**DOCUMENT 00 90 00
ADDENDUM**

ADDENDUM NO. [1] Date: February 17, 2020

**RE: WESTERN TECHNICAL COLLEGE
 APPRENTICESHIP CENTER REMODEL
 2860 21ST PLACE SOUTH
 LA CROSSE, WISCONSIN 54601
 HSR PROJECT NO. 19021**

This Addendum consists of [2] page, [1] specification sections and [9] 30 x 42 drawings.

C200

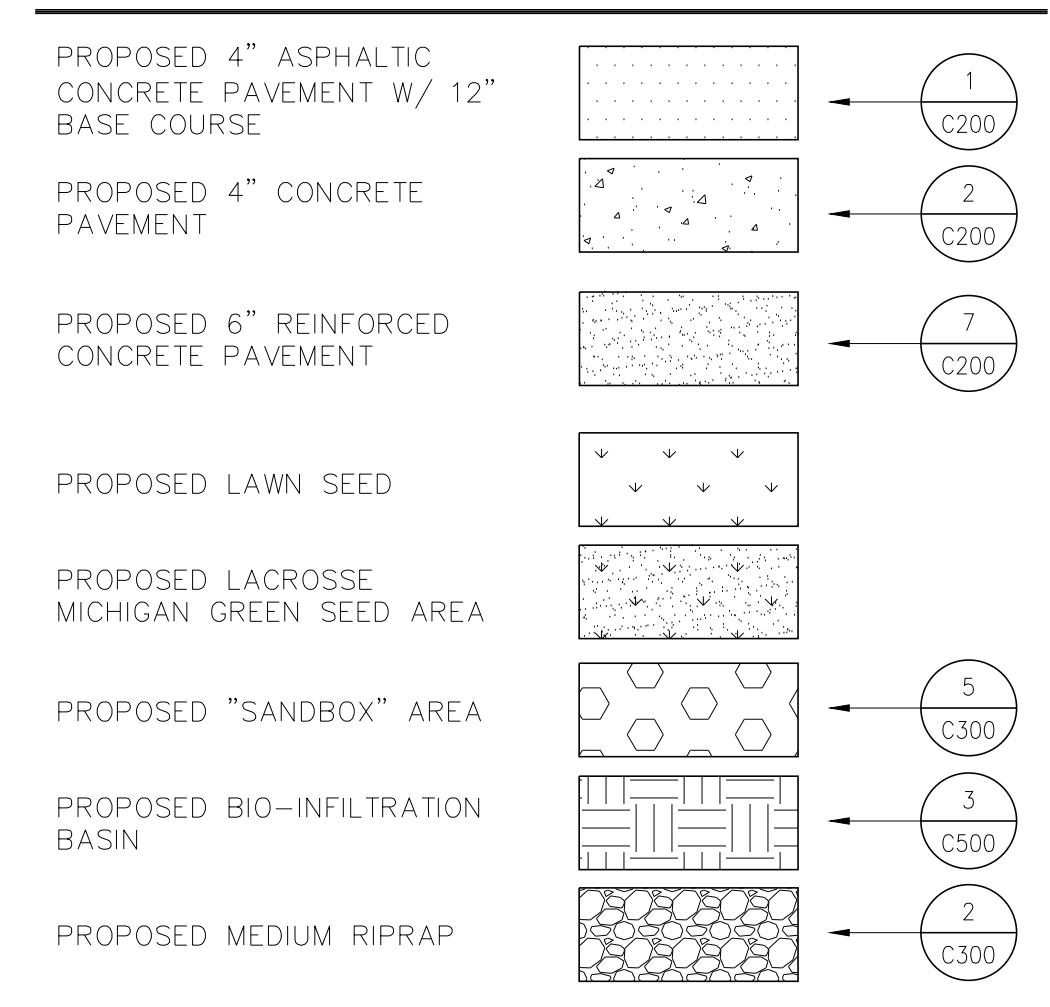
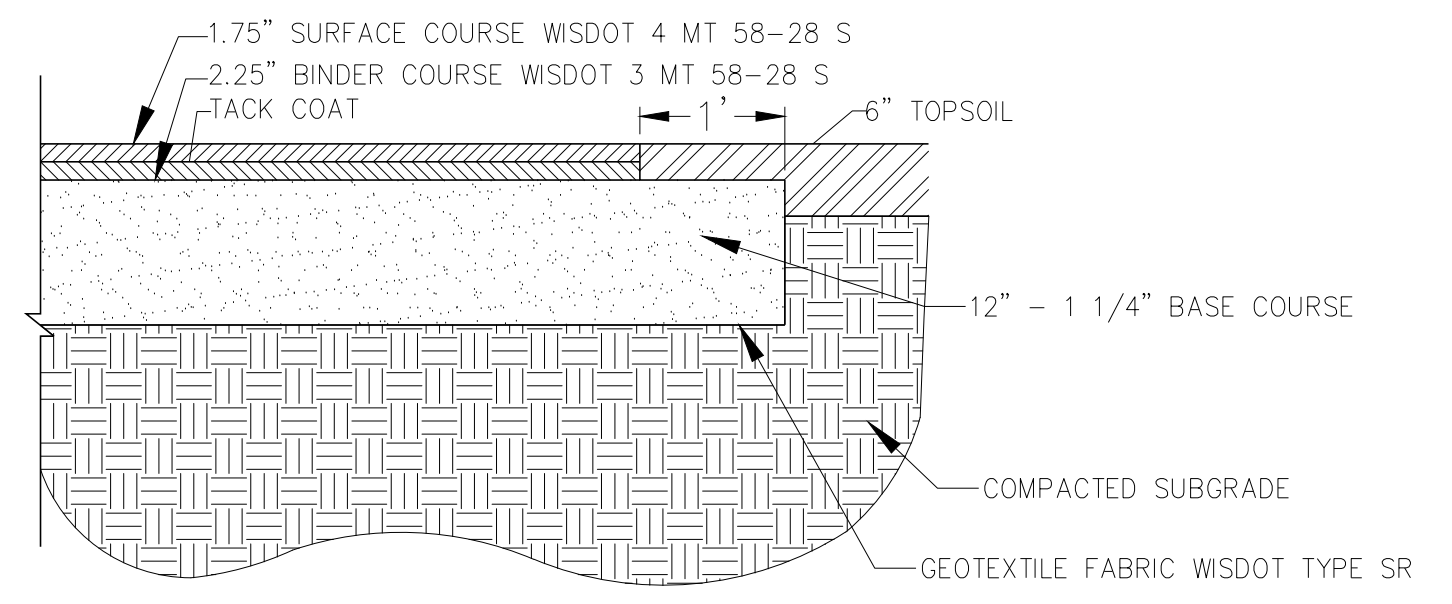
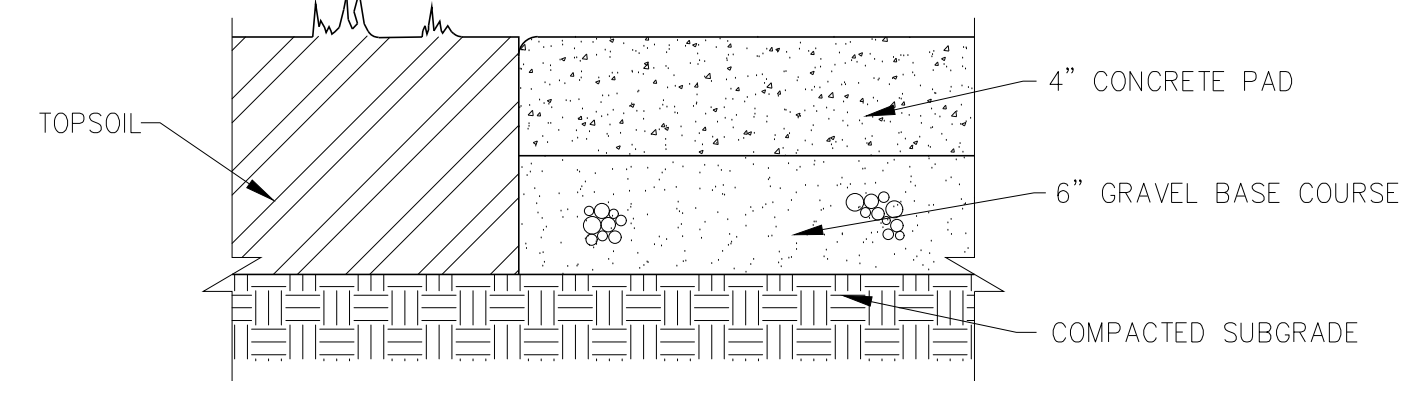
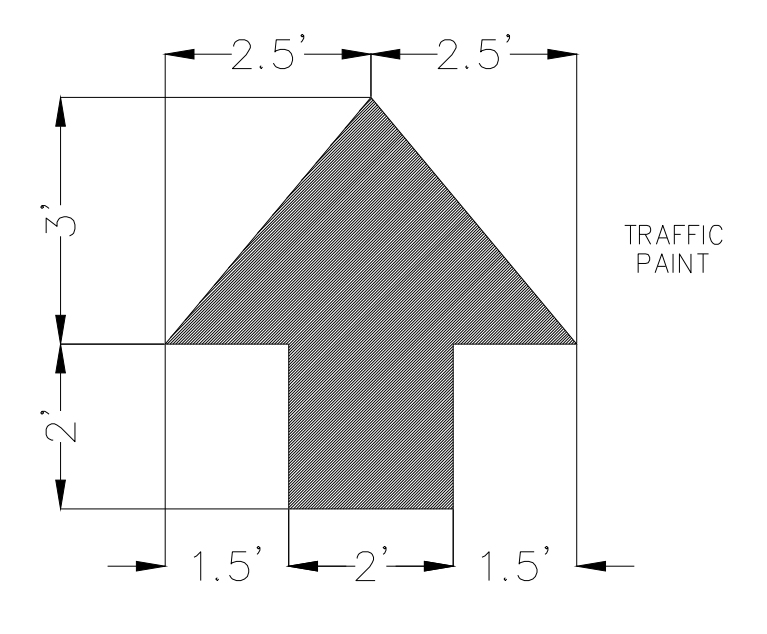
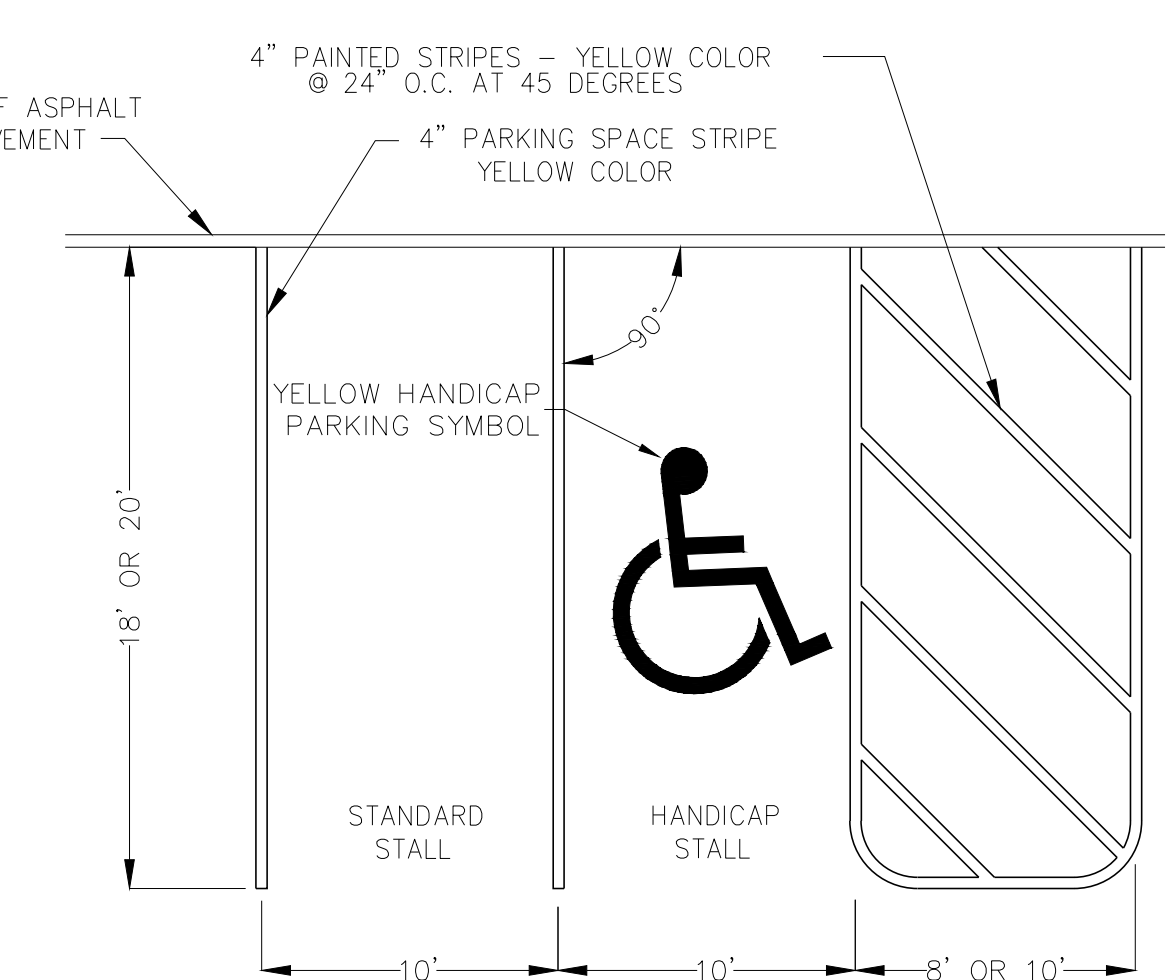
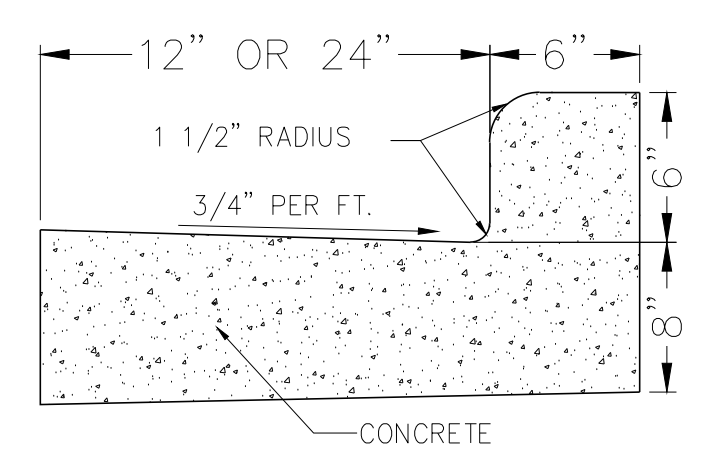
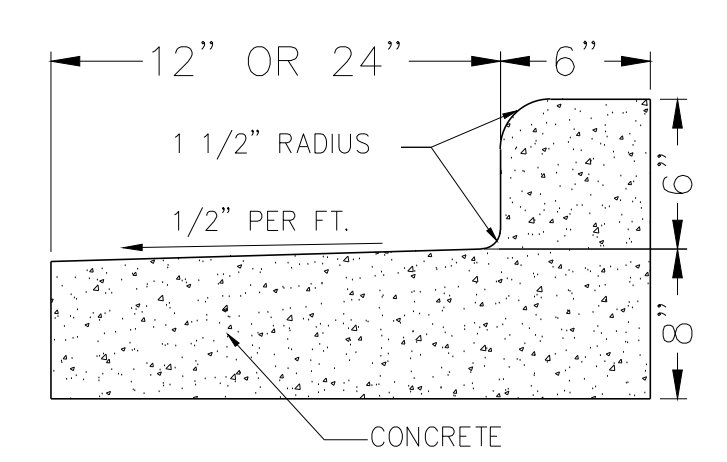
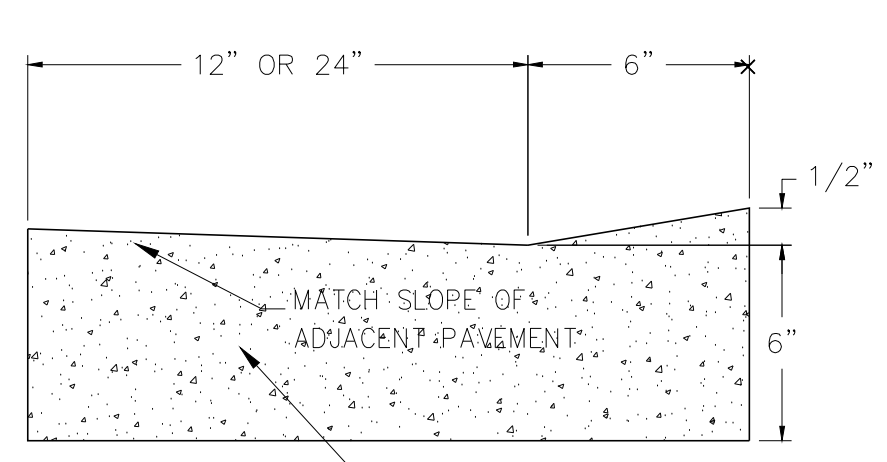
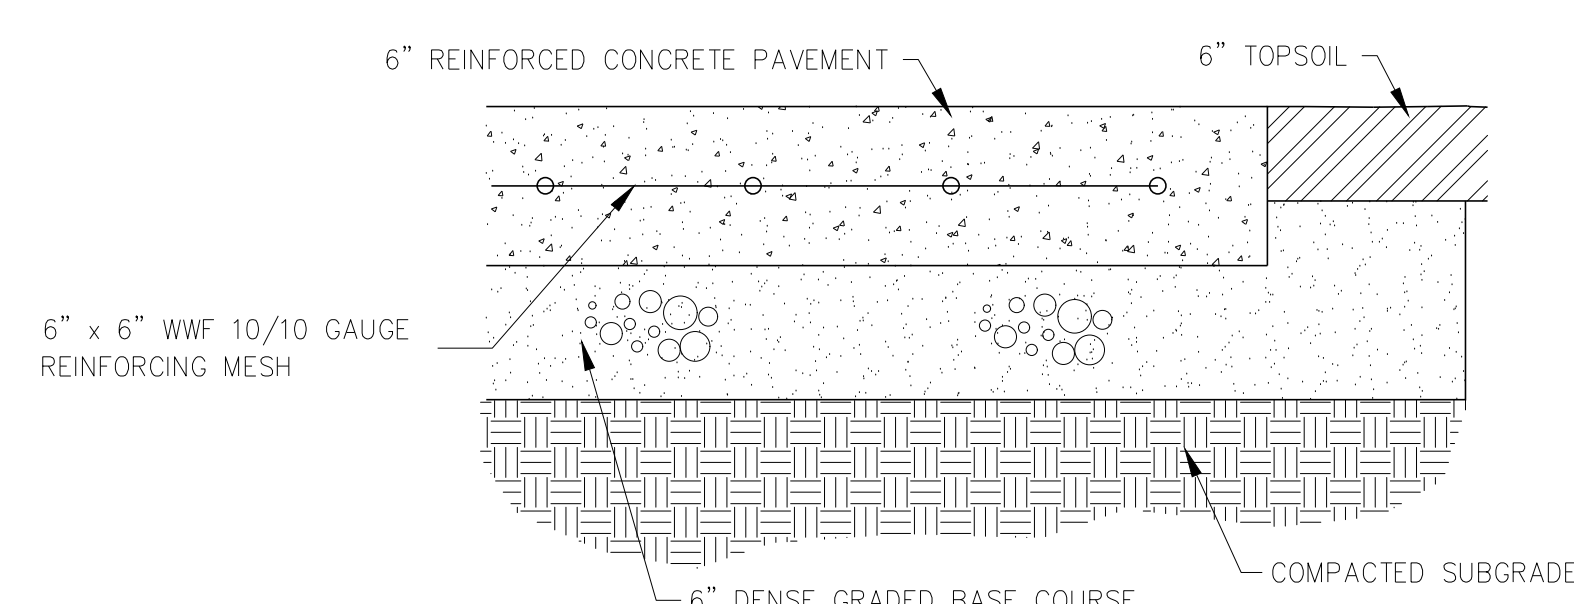
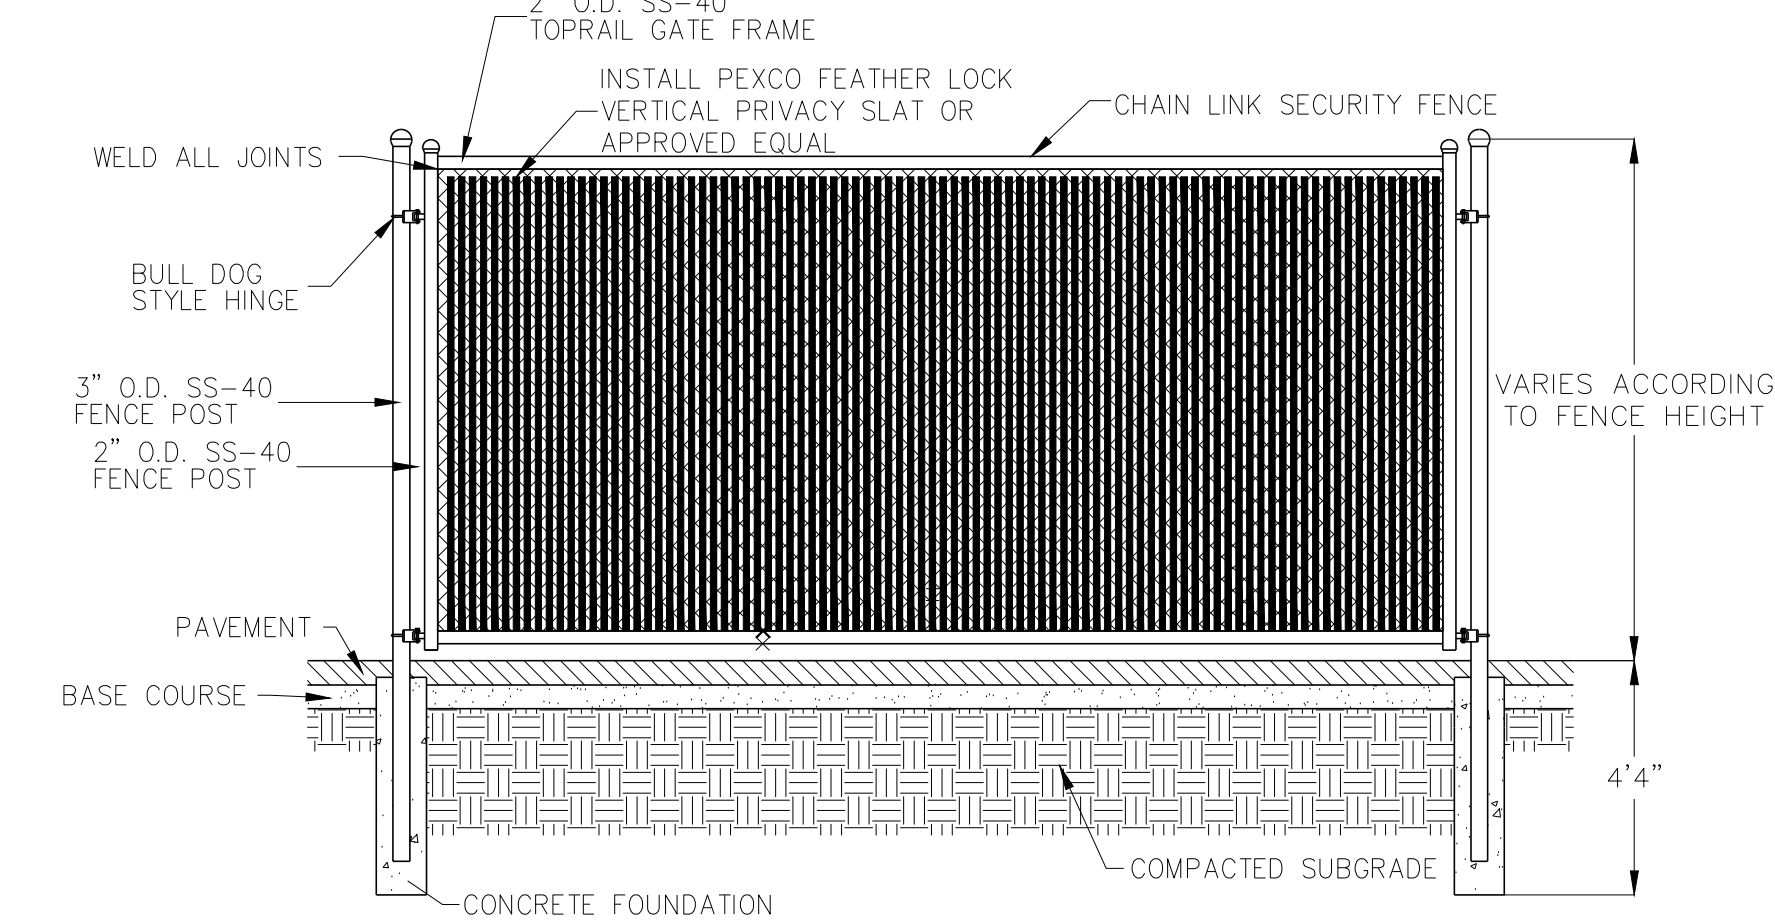
4. Sheet C200 LAYOUT PLAN 30 x 42 attached hereto
 - a. Revisions clouded on Drawing.
5. Sheet A100 FIRST FLOOR REMODEL PLAN 30 x 42 attached hereto
 - a. Revisions clouded on Drawing.
